CUSTOMER SERVICE BULLETIN

ADDENDA SHEET

NCX-3 ADDENDA SHEET

NCX-3
CSB 66-2

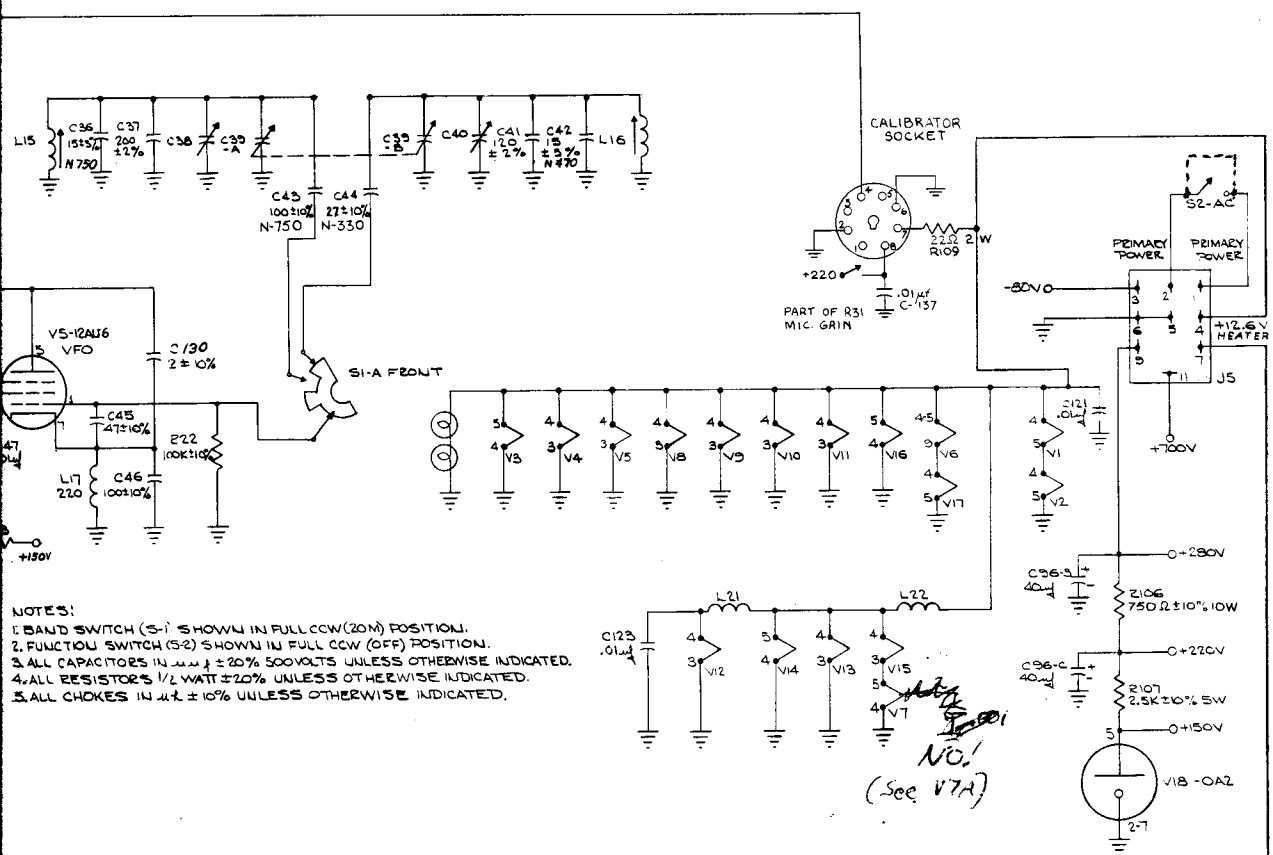
* R44 removed per letter from National

NCX-A SCHEMATIC

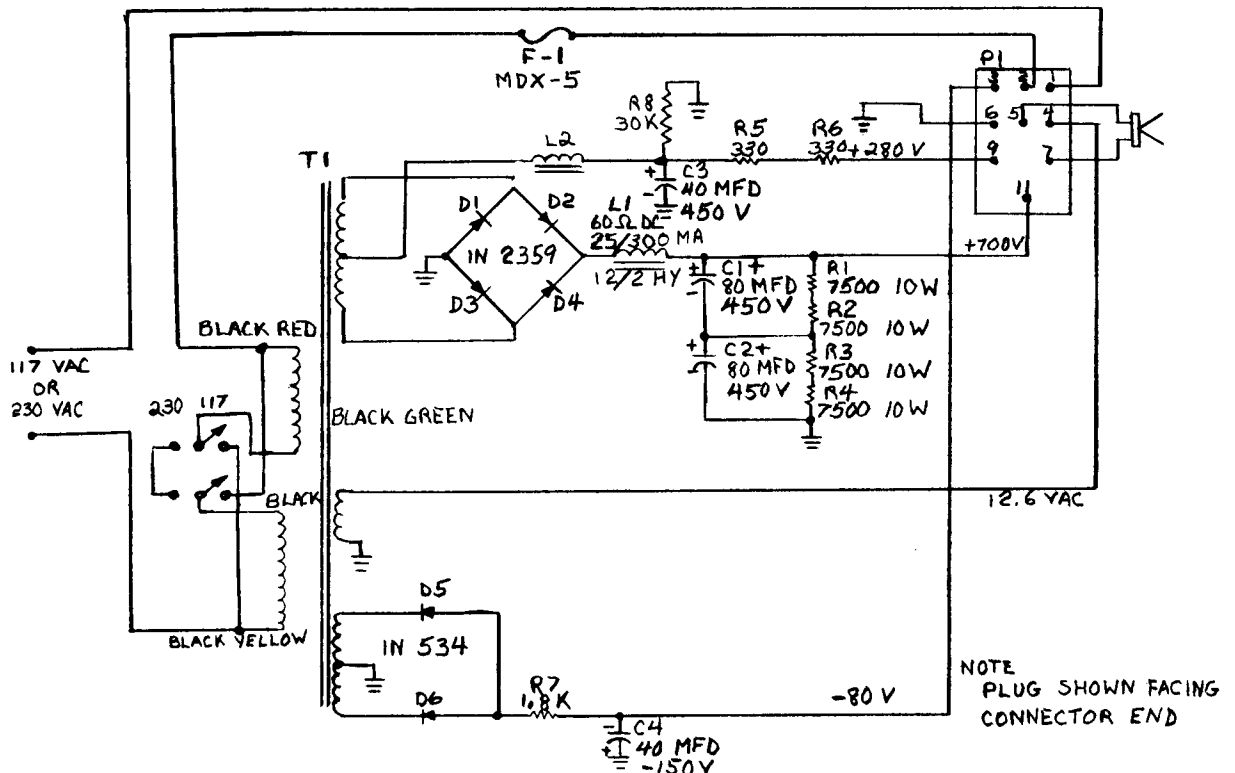
1. Resistor R7 has been changed from $1000 \Omega \pm 10\%$ to $1800 \Omega \pm 10\%$.
2. A 0.01 uf 600 volt capacitor from one side of the AC line to chassis is not indicated on the schematic.
3. A revised primary power schematic is shown below:
